TRANS/WP.29/838  
23 January 2002

World Forum for Harmonization of Vehicle Regulations (WP.29)

DRAFT SUPPLEMENT 1 TO REGULATION No. 112

(Headlamps emitting an asymmetrical passing beam)

OVERVIEW OF OPERATIONAL PERIODS  
CONCERNING TEST FOR STABILITY OF PHOTOMETRIC PERFORMANCE

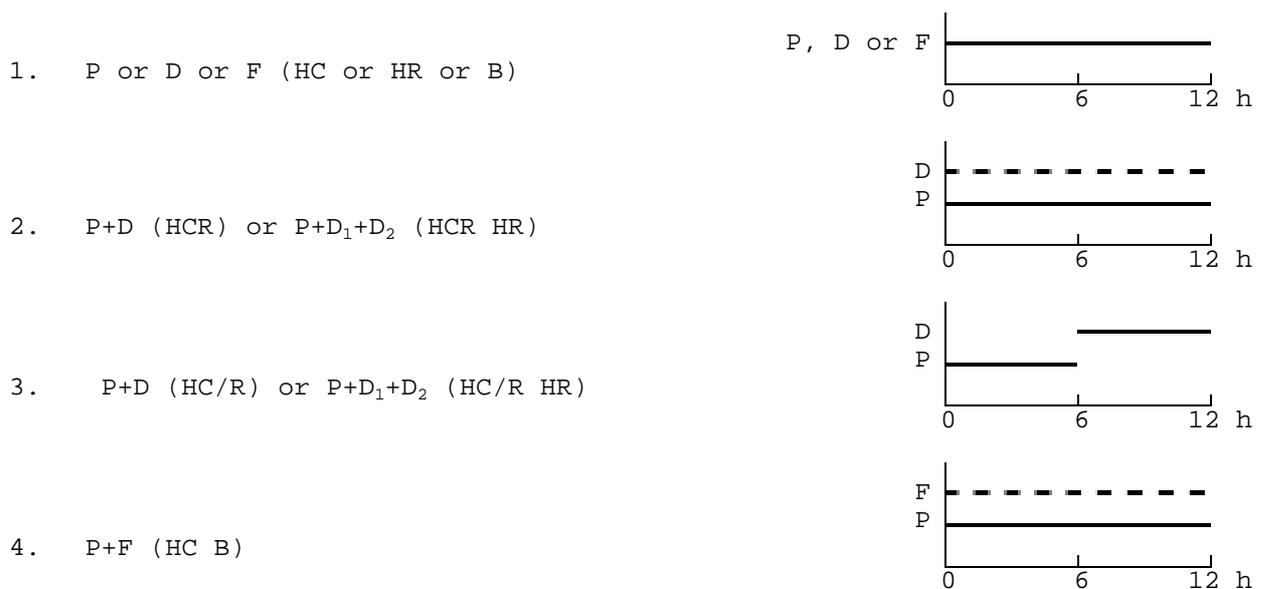
Add a new Annex 8, to read:

Abbreviations: P: passing beam lamp

D: driving beam lamp (D<sub>1</sub> + D<sub>2</sub> means two driving beams)

F: front fog lamp

----- : means a cycle of 15 minutes off and 5 minutes lit.
